2014 - 2015 Corvette: GM TechLink: Break-In Oil Change for Corvette Included in Chevrolet Complete Care Program

Subject: Break-In Oil Change for Corvette Included in Chevrolet Complete Care Program

Model and Year: 2014 - 2015 Chevrolet Corvette Stingray with Z51 and Z06 Models

Date: January 22, 2015

Fig. 2

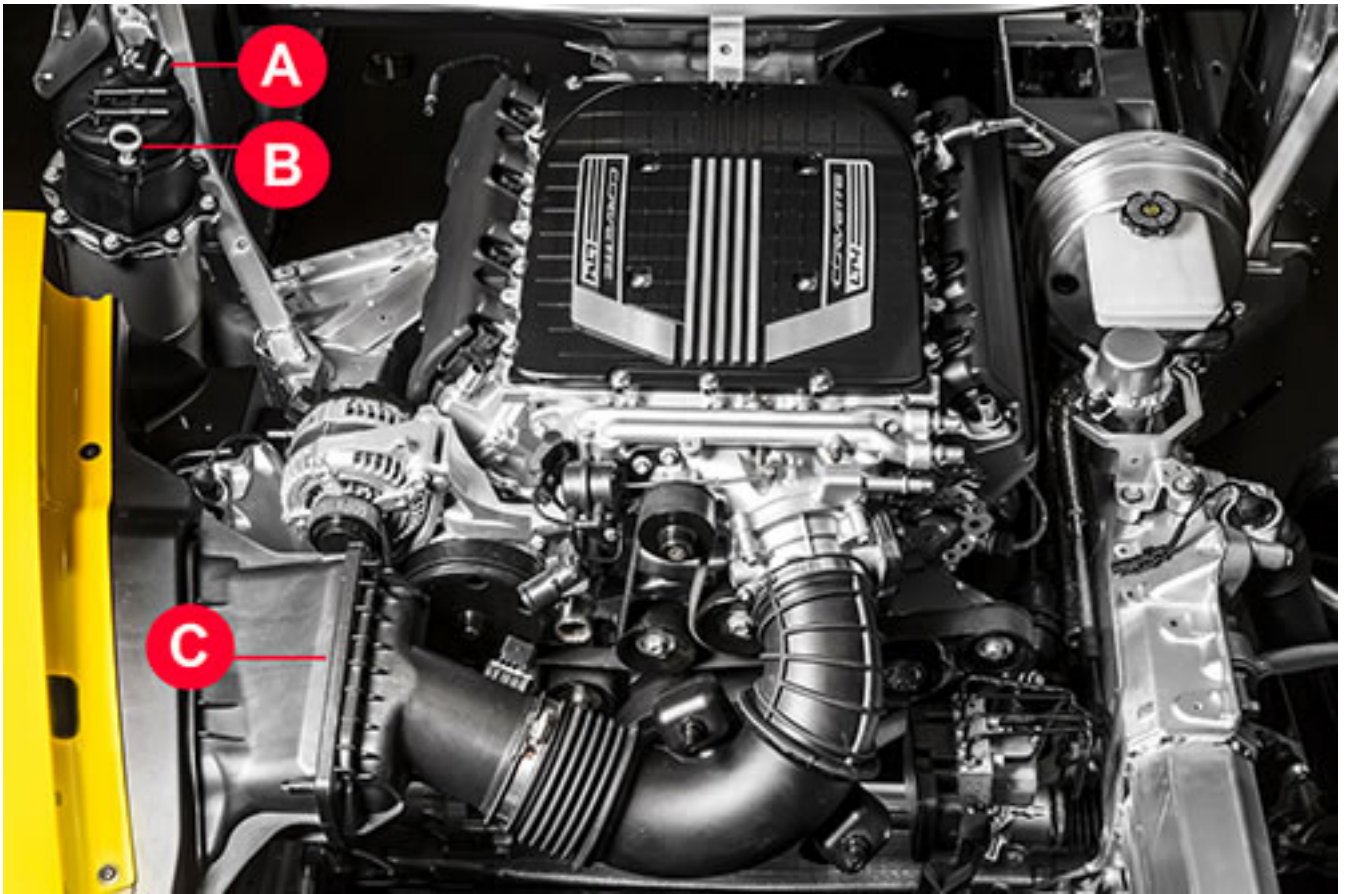
A new mileage interval has been established for the first engine oil change on 2014-2015 Corvette Stingray models with the Z51 Performance Package and Z06 models. These vehicles are equipped with an engine featuring a dry sump oil system. The first oil change should take place at 500 miles (800 km) on these vehicles.

If the vehicle is driven continuously at a high engine speed with the first factory oil fill, silicone sealants in the engine's gaskets may degrade the anti-foaming properties of the oil. This may lead to oil leaking out from the air cleaner assembly due to the oil foaming condition. The oil foam does not affect the engine's durability, but changing the oil at 500 miles will help prevent oil foaming in the future because the silicone sealants are removed with the original oil.

Once the break-in oil change is performed and the Oil Life Monitor is reset, owners should follow the Oil Life Monitoring system for all future oil change needs.
